ADDENDUM NO. 3

SUBJECT: ADDENDUM NO. 3 TO THE BIDDING DOCUMENTS FOR

Water Treatment Flood Protection Wall
Public Water Supply District No. 2, Jefferson County, Missouri
HR No. 290-0367

PRECAST CONCRETE MANHOLE	METROPOLITAN ST. LOUIS SEWER DISTRICT <i>Standard Details of Sewer Construction</i>		
	Dr. WSH/SAM Ch. J.C.K.	2009	SHEET 21 (REV)

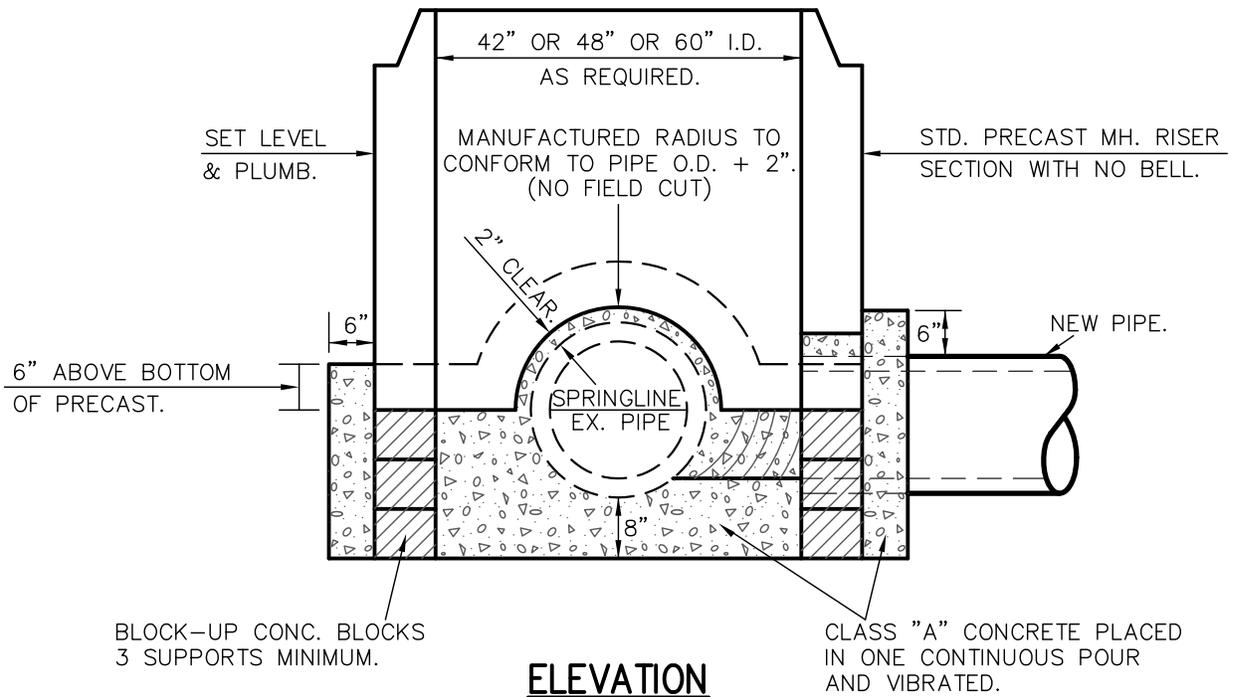
1. Add the attached MSD Precast Concrete Manhole Detail, Sheet 21 (Rev) to Plan Sheet C-502 - Miscellaneous Details, in its entirety.
2. Add the attached MSD Precast Concrete Manhole On Existing Pipe With Continuous Flow Detail, Sheet 22 to Plan Sheet C-502 - Miscellaneous Details, in its entirety.

Question: Plan Sheet C-101 - Please indicate the depth and size of the two new manholes required to relocate the existing lime sludge line.

Answer: According to the District, the existing lime sludge line is approximately 6 to 7 feet deep. So the two new manholes would be approximately 6 to 7 feet deep. Final manhole depth will need to be field verified once the existing lime sludge line is exposed. The proposed manholes shall have 48" inside diameter and shall be constructed pursuant to MSD standards for precast concrete manholes (please see attached MSD detail sheet). The base of the manhole shall be constructed
